DUKE POWER COMPANY  
POWER BUILDING  
422 SOUTH CHURCH STREET, CHARLOTTE, N. C. 28242

November 2, 1978

Please find attached Duke Power Company's response to the NRC positions on fire protection which were transmitted by the staff's letter of September 6, 1978. These responses reflect the agreements reached with the staff in our meeting on September 27-28, 1978. In this meeting a commitment to submit this information on November 1, 1978 was made, however, due to administrative delays it is being submitted one day late.

The following responses are presented to docket the final positions on fire protection transmitted to Duke in the NRC's September 6, 1978 letter and resolved in the September 27-28 meeting between Duke and the NRC.

FIGURE 9.1

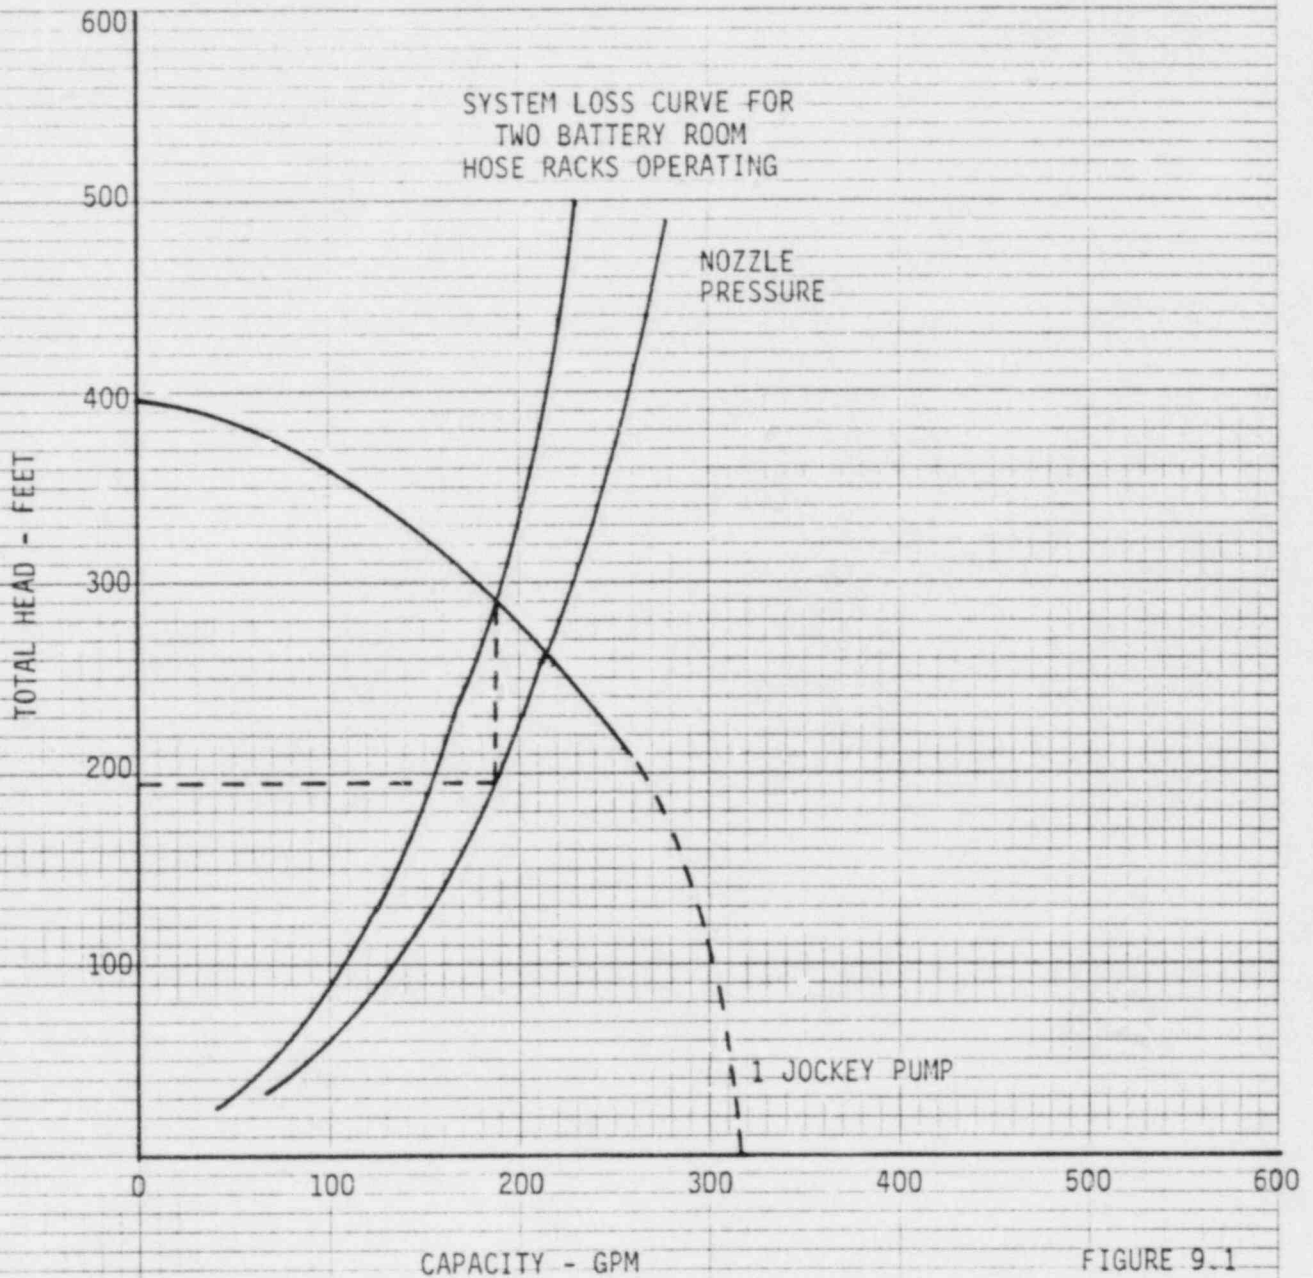
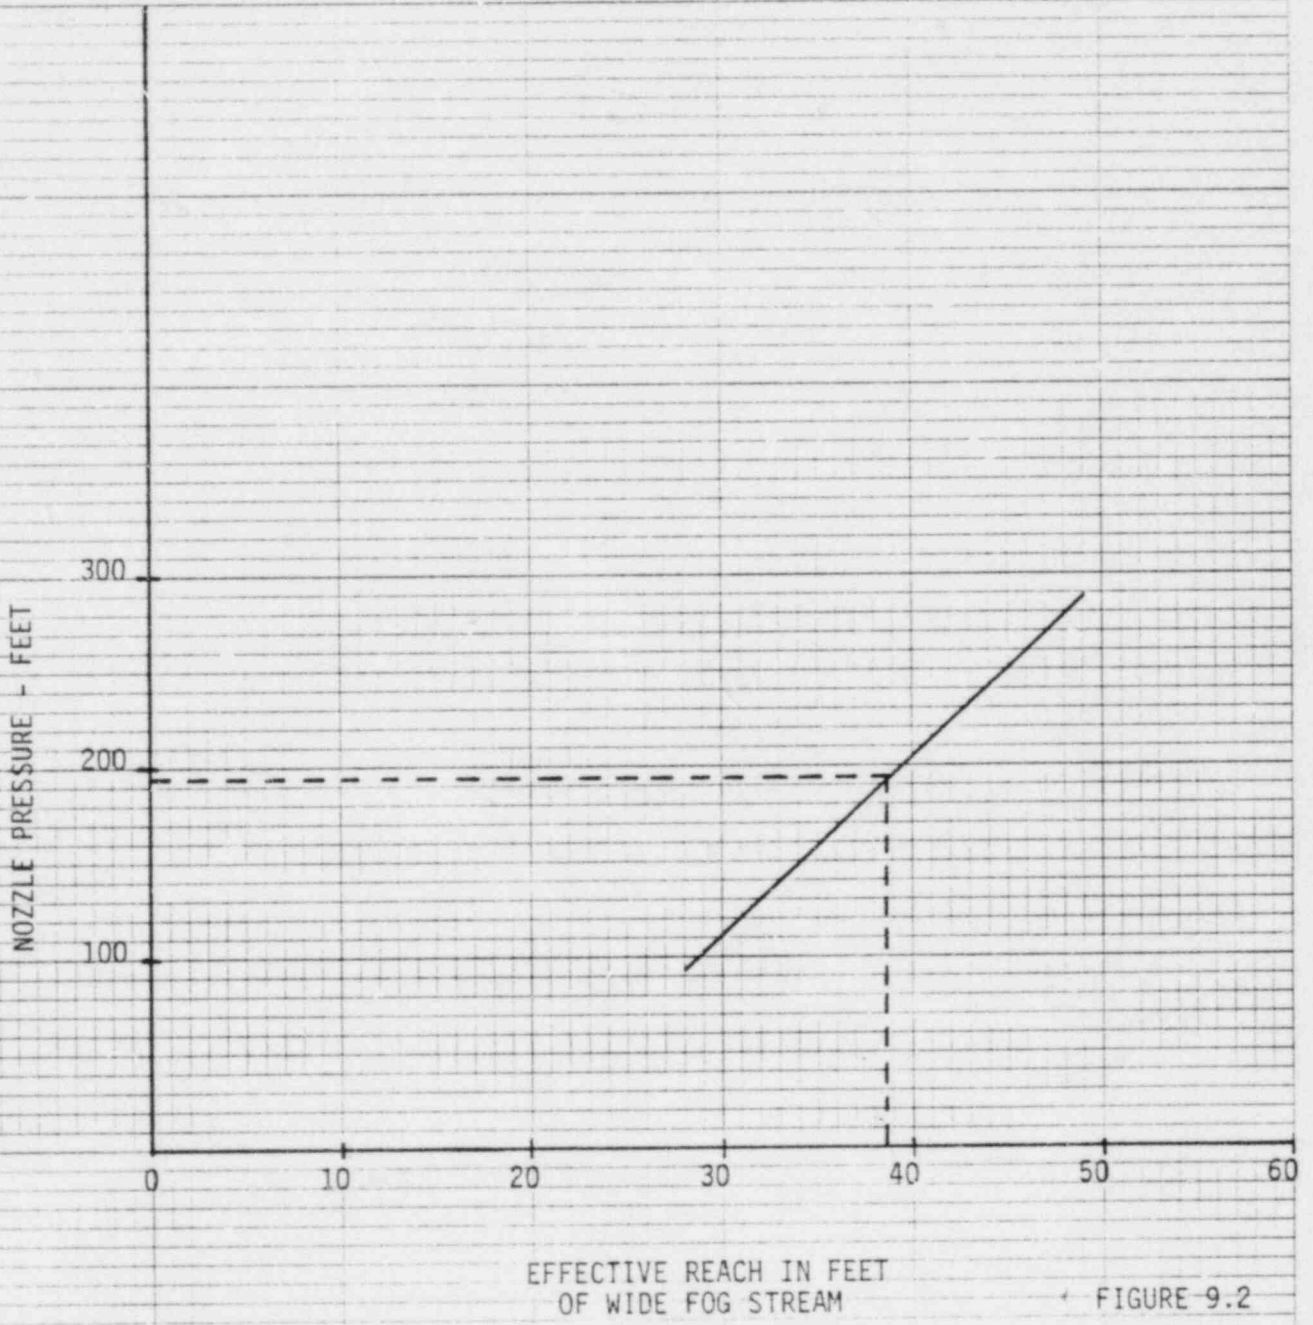
9. Your response is incomplete. You have not provided sufficient information to demonstrate that the 1 inch bypass line of the deluge valve would be sufficient to supply the required water flow to the auxiliary reactor building fire suppression system. Further, you have not provided assurance that a fire at the batteries will not affect the fire protection system water supply. We will need this information to complete our review.

The two deluge valves which control the fire protection water supply for the Auxiliary Building may be manually tripped open at the valve upon loss of electrical power. In addition, a normally open 1 inch bypass line is provided around each deluge valve. As shown in Figure 9.1, these lines have adequate capacity to supply two hose stations at the battery rooms. This figure shows the head loss curve for the piping system through the 1 inch bypass lines and out through the hose nozzles. Also shown are curves depicting fire protection jockey pump performance. As can be seen, with only one jockey pump in operation, the total flow to the two hose racks will be 188 gpm or 94 gpm each with a nozzle pressure of 195 feet. Figure 9.2 shows the effective reach of a wide fog stream versus nozzle pressure for these nozzles. From this figure, it can be seen that the effective reach with 195 feet of nozzle pressure is approximately 39 feet.

These two features provide assurance that a fire at the batteries will not adversely affect the fire protection system water supply.

# CASE 5

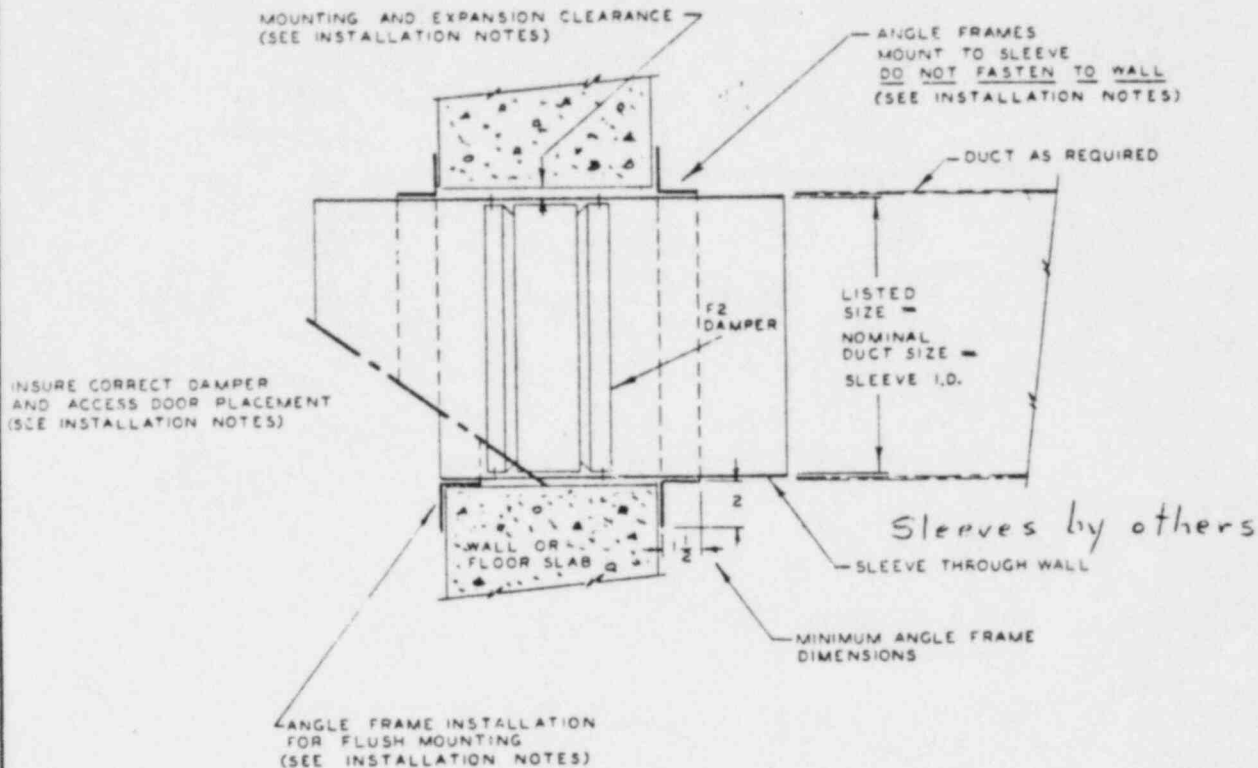
31. Your response does not address item (b) of our question number 31. Provide the requested information. Also provide the test results for the wall assemblies. We will require this information to complete our review.

#### CASE 5

Case 5 consists of standard fire dampers, manufactured by Tuttle and Bailey, installed in non-safety related ducts which pass through a fire rated barrier with the top of the opening flush with the ceiling.

The duct work in Case 5 areas is constructed in accordance with SMACNA high velocity duct construction standards.

The fire dampers are installed in a metal sleeve within the confines of the wall in accordance with the manufacturer's instructions. The minimum gauge metal sleeve is 16 gauge. The fire damper is welded or bolted inside the sleeve. The sleeve extends from both sides of the wall from 2 inches to 24 inches. The ducts on both sides of the wall

are connected to the sleeve by companion angle flanges.

The manufacturer's instructions, Tuttle and Bailey drawing F2 (attached), were followed with the following exceptions:

1. In some instances, the fire dampers are welded inside the sleeve, using 1 inch welds, 8 inches on center.
2. The flashing angles, in some instances, are pop-riveted to the sleeve with pop rivets, spaced a maximum  $3\frac{1}{2}$ " on center.

3. In order to maintain heavy duct construction standards, companion angle flanges are used to connect the duct to the sleeve.
4. The clearances between the sleeve and the wall and ceiling vary from 0-12 inches. To maintain the integrity of the fire barrier a minimum of 10 inches of RTV silicon foam, backed with 1 inch thick cerafiber board in both sides of the wall, is used to seal the opening in accordance with paragraph 3-3.81., NFPA 90A. The foam is compressible; therefore, the duct can expand.

5. The flashing angles are constructed from 16 gauge metal when the clearance between the sleeve and wall does not exceed 4 inches. Where the clearance between the sleeve and wall exceeds 4 inches, 11 gauge metal is used.
